Re: Chevron 2024 Flare Minimization Plan

Thank you for the opportunity to comment on Chevron's 2024 Flare Minimization Plan (FMP). The following comments are informed by CBE's many decades of organizing alongside Richmond residents, and by our technical knowledge of the oil refining and hydrogen production processes, including existing flaring regulations and feasible flaring reductions.

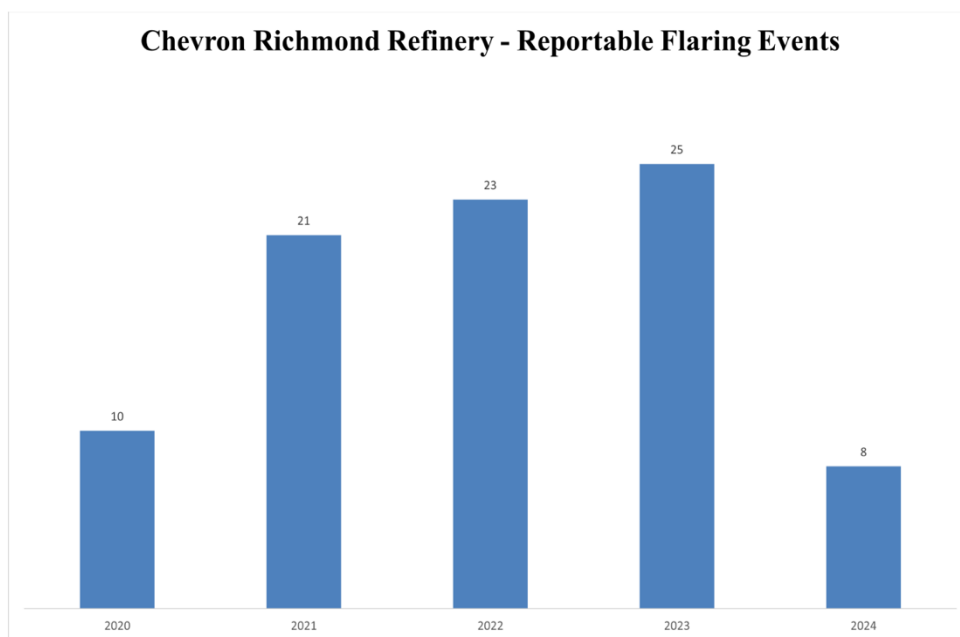
Having recently reviewed Chevron's 2022 and 2023 FMP formats, much of which is copy and pasted each year, we were surprised to see dramatic changes in the Executive Summary graphs for Chevron's 2024 FMP. In particular, the previous graphs that highlighted differences between the Hydrogen Plant and the rest of the refinery, and the others that tracked flaring patterns over time were eliminated. In their place were graphs that focused exclusively on flaring events during the FMP period. While we certainly welcome the inclusion of additional information on each flaring event during the FMP period – their length, vent gas flow, and emissions – Chevron has managed to focus so narrowly on the 2024 reporting period that it has compromised the public's ability to track their flaring patterns across years across years.³ Furthermore, as we discuss in Section 2, one of the new graphs seriously manipulates the data to give the impression that Chevron's flaring has decreased when it has not.

To avoid dramatic changes in graphs year to year and improve public accessibility, CBE encourages the Air District to outline a standard set of graphs for refineries to produce each year. This would build trust with the public, who could count on being able to see and interpret these graphs in every FMP, and track changes over time. Residents would not only feel empowered to hold Chevron accountable for flaring in a single year, but across multiple years. As we discuss in the conclusion, these graphical standards could be rolled out to other refineries to increase public accountability across the Air District and ease BAAQMD's review process.

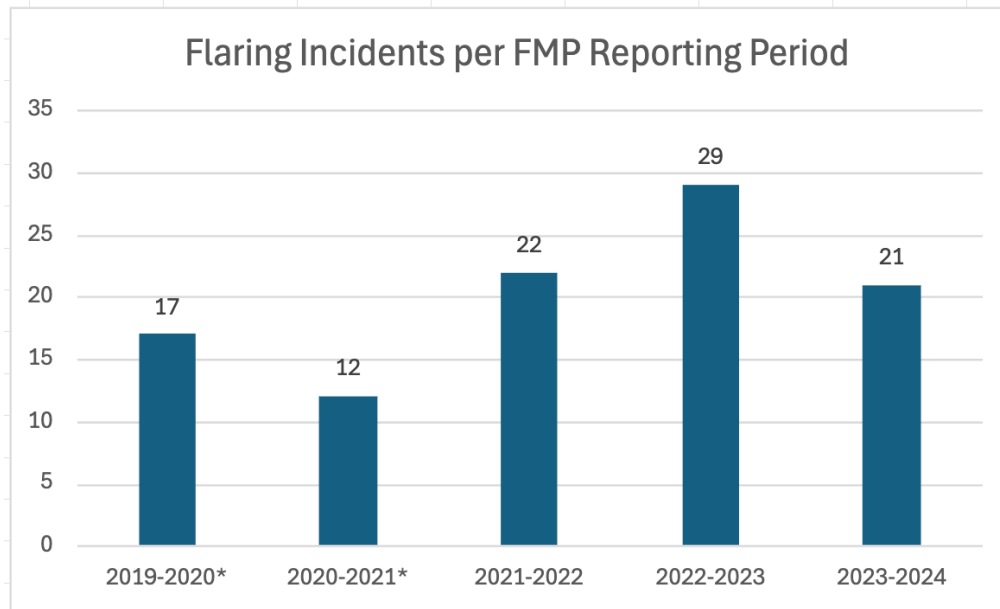
As it currently stands, Chevron's 2024 FMP misrepresents data to suggest that flaring has decreased at the refinery when it has not. This is extremely misleading to the public. The most serious example of this is the first chart in the Executive Summary, which shows reportable flaring events by year and suggests that there was a huge drop off in flaring in 2024 (see image below).⁴

Of course, we would be thrilled if flaring genuinely had decreased. However, the visible decrease does not reflect an actual decrease in flaring, but rather that the 2024 bar only measures data through June 30, 2024, meaning that half of the year is not included in the 2024 data. At the very least, Chevron should clearly explain and disclaim that 2024 only reflects half the year. A more accurate and truthful graph would present the data by FMP reporting period, showing that there has not been a meaningful drop in flaring events, as shown in CBE's revised chart below:

As this corrected graph makes clear, the 2023-2024 reporting period is roughly on par with previous years and has not seen the dramatic decrease that their current summary graph misleads readers of the report to believe. We strongly encourage BAAQMD to require Chevron to update this misleading graph as part of the larger set of graphical standards discussed in the previous point.
